Technical Bulletin

Document Number: 1212021

Models: 110, PT110

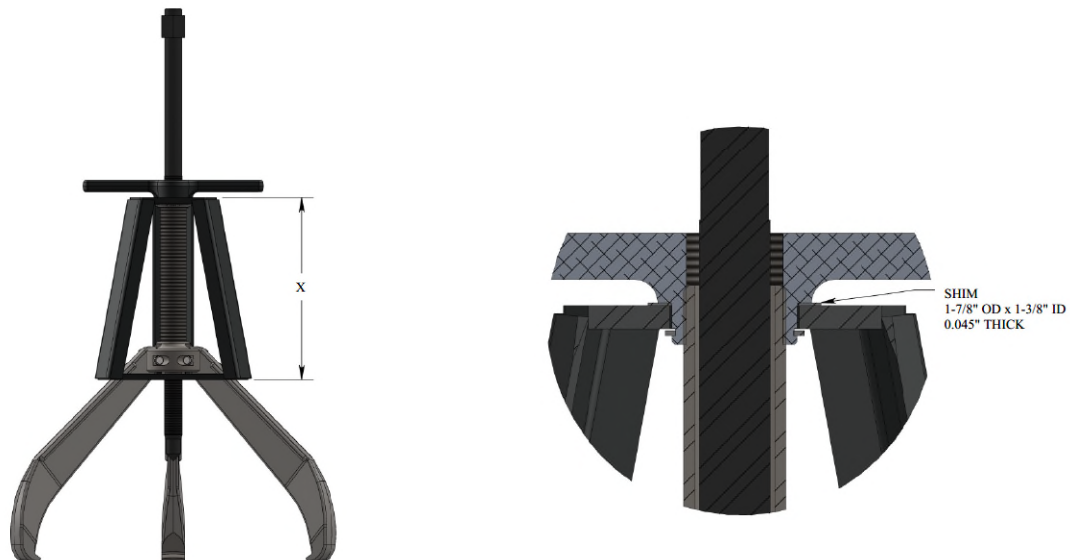
Due to variation in casting dimensions, shims may be used on Posi Lock pullers to ensure puller performance. If service is required, and a cage needs to be replaced, please use the image and information below to determine if a replacement shim is required.

If the length of dimension X is 7.81" or greater, a shim is not needed.

If the length of dimension X is between 7.75" and 7.80", a shim is required. See image above for location and shim dimensions.
